## Executive Director’s Recommendation

Commission Meeting: December 5, 2019

<p><b>PROJECT</b>  <b>Arlington National Cemetery Southern Expansion and US Air Force Memorial Modification</b>                  Arlington National Cemetery                  Arlington, Virginia</p> <p><b>SUBMITTED BY</b>                  United States Department of Defense                  United States Army Corps of Engineers</p> <p><b>REVIEW AUTHORITY</b>                  Federal Projects in the Environs                  per 40 U.S.C. § 8722(b)(1)</p>	<p><b>NCPC FILE NUMBER</b>                  8009</p> <p><b>NCPC MAP FILE NUMBER</b>                  1.61(00.00)45039</p> <p><b>APPLICANT’S REQUEST</b>                  Approval of comments on concept plans</p> <p><b>PROPOSED ACTION</b>                  Approve comments on concept plans</p> <p><b>ACTION ITEM TYPE</b>                  Staff Presentation</p>
---	--

Approval of Comments on Concept Plans

New Parking Garage and New Operations Facility

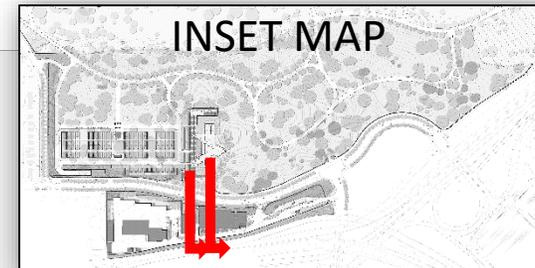
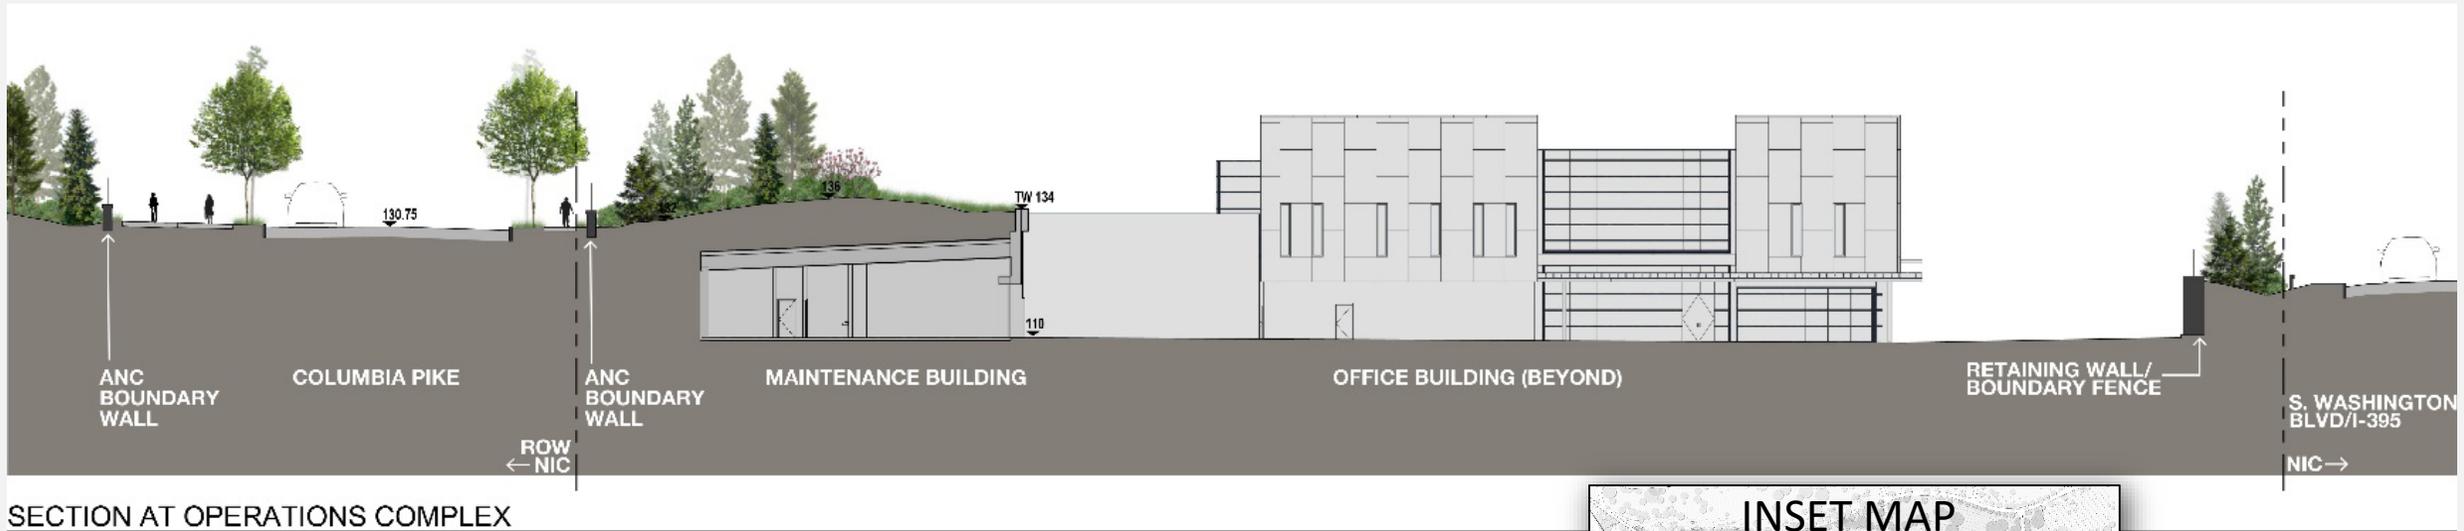
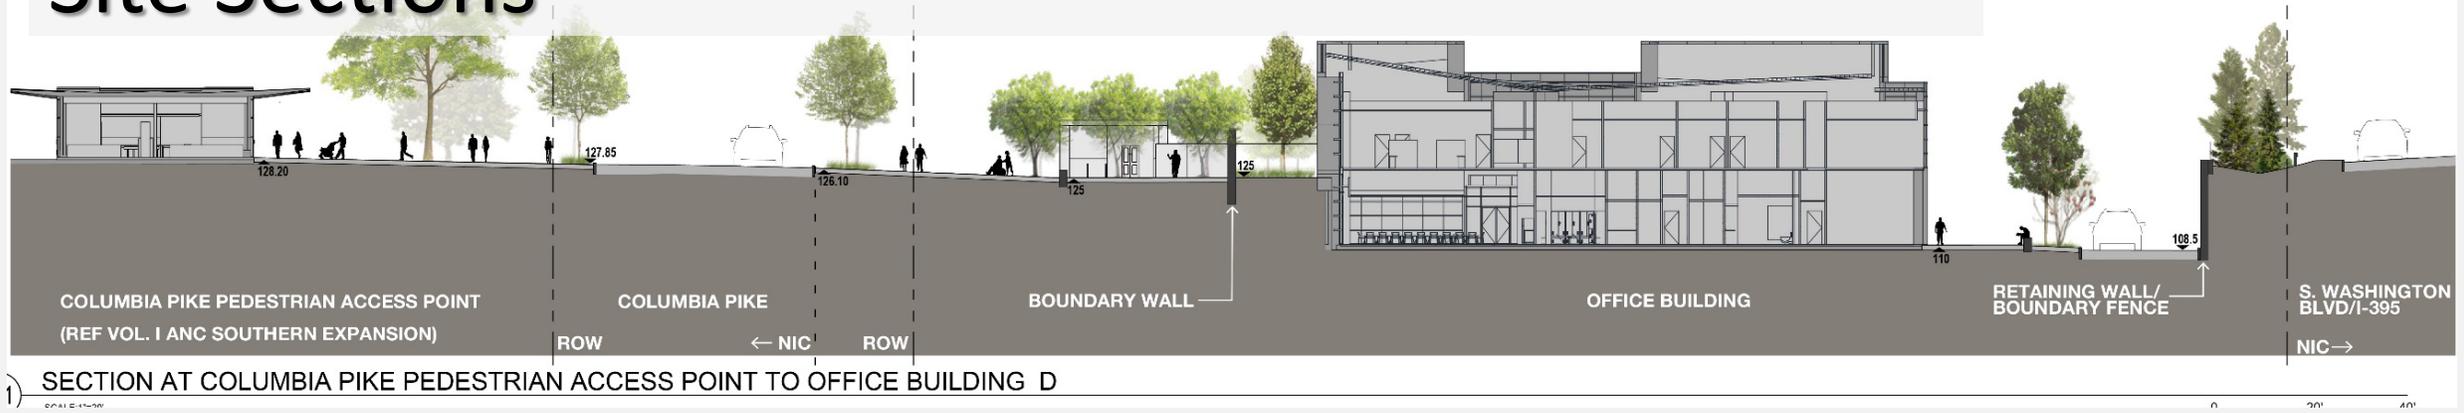
**Finds** the current design of the parking garage access control point is very utilitarian and is not welcoming to visitors.

**Recommends** the applicant either integrate the parking garage access control point into the topography or more closely associate this building with the architecture of the rest of ANC.

**Notes** that while the site's topography hides most of the operations facility, the Navy should continue to explore ways to further integrate the buildings into the site and screen with landscaping.

# Site Section

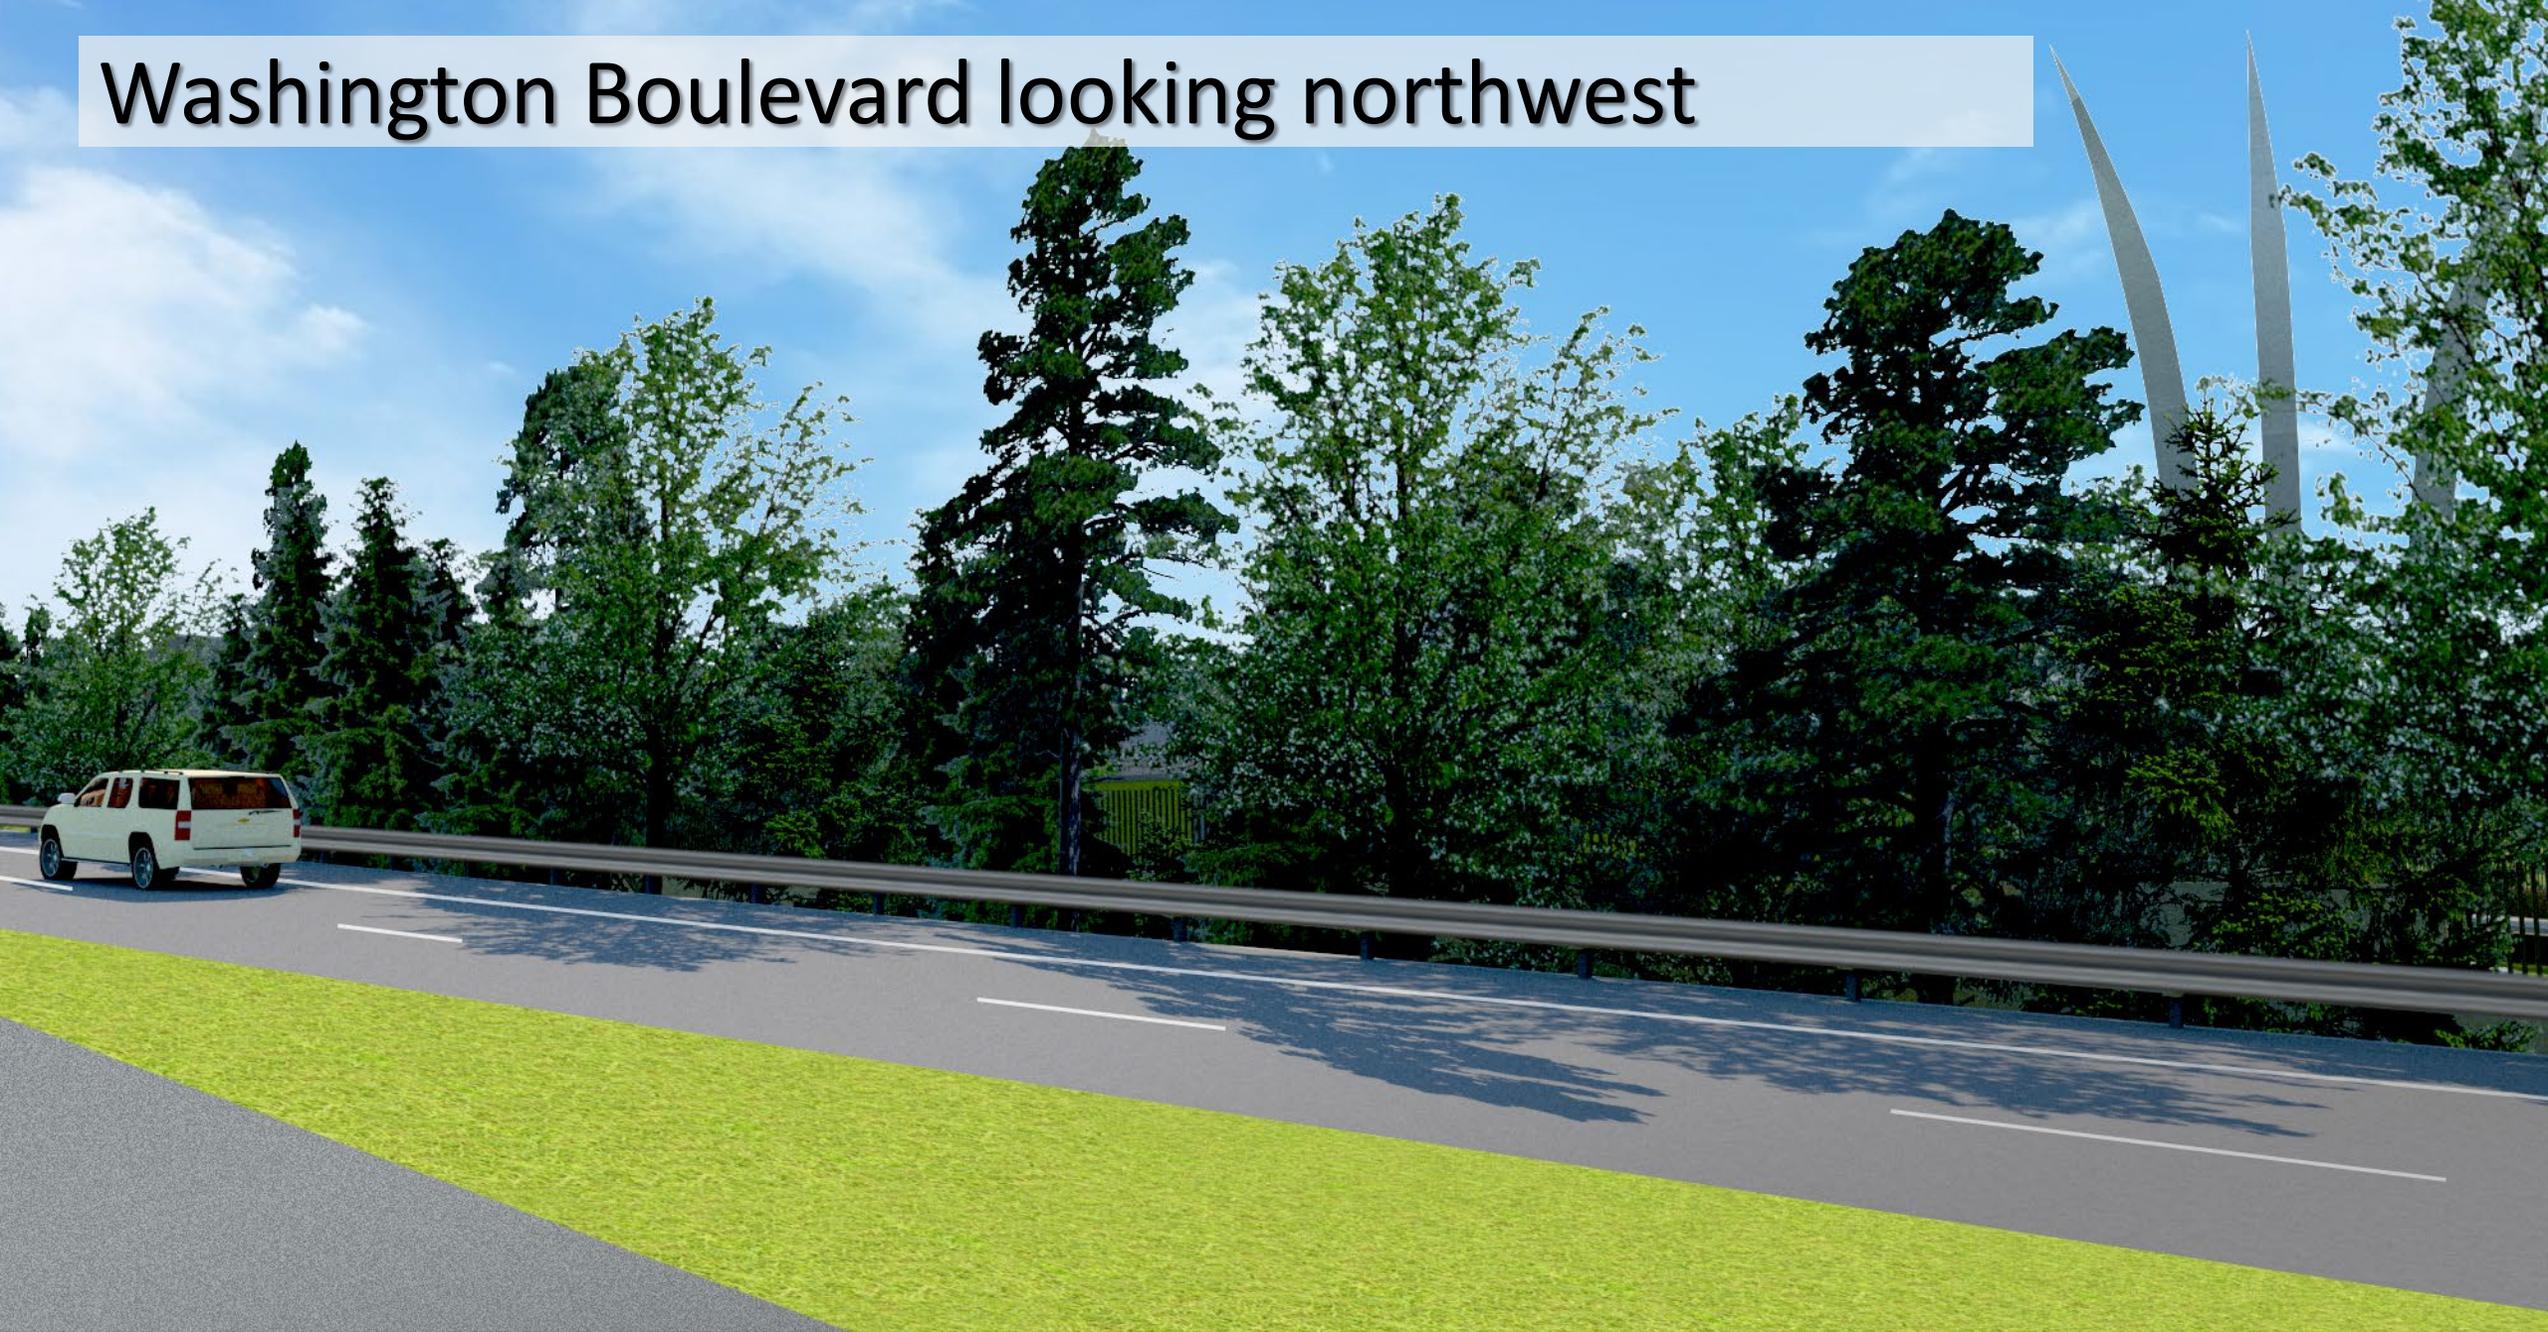
**Requests** the USACE develop site sections through the columbarium area, both east/west and north south, to understand the grade changes in this area more fully. In addition, sections through the in-ground burial areas and through the Air Force Memorial would also be helpful in understanding the visibility of and access to these areas.

# Site Section – U.S. Air Force Memorial Regrading

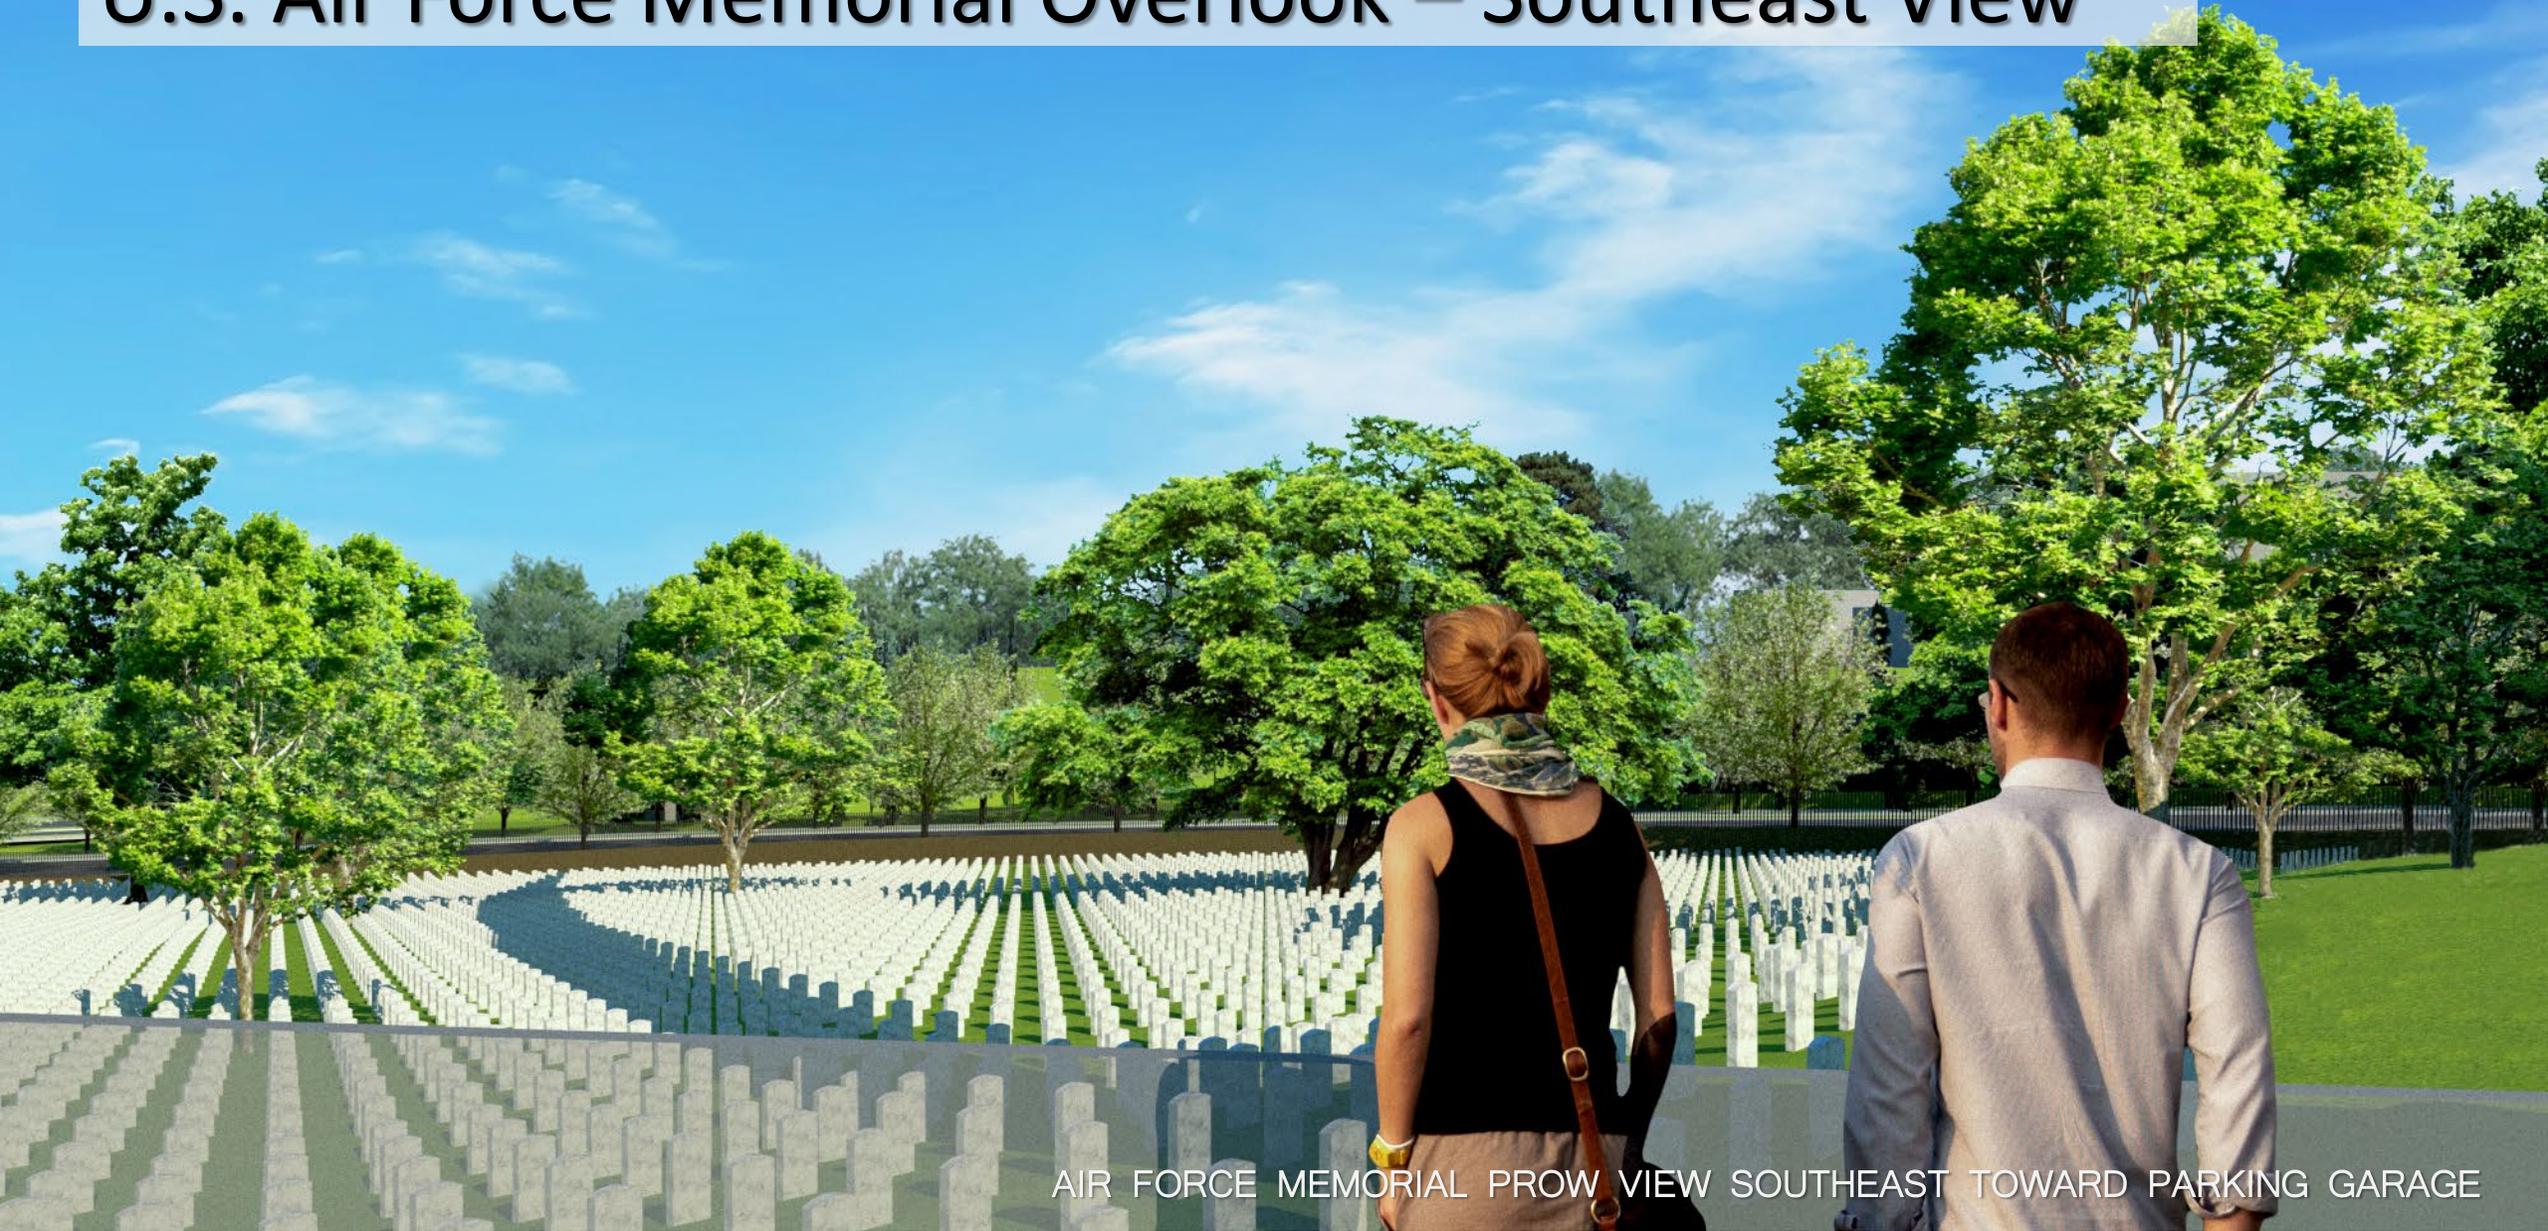
**Recommends** the applicant evaluate landscape screening around the high retaining wall of the memorial overlook to soften the transition to adjacent burial areas.
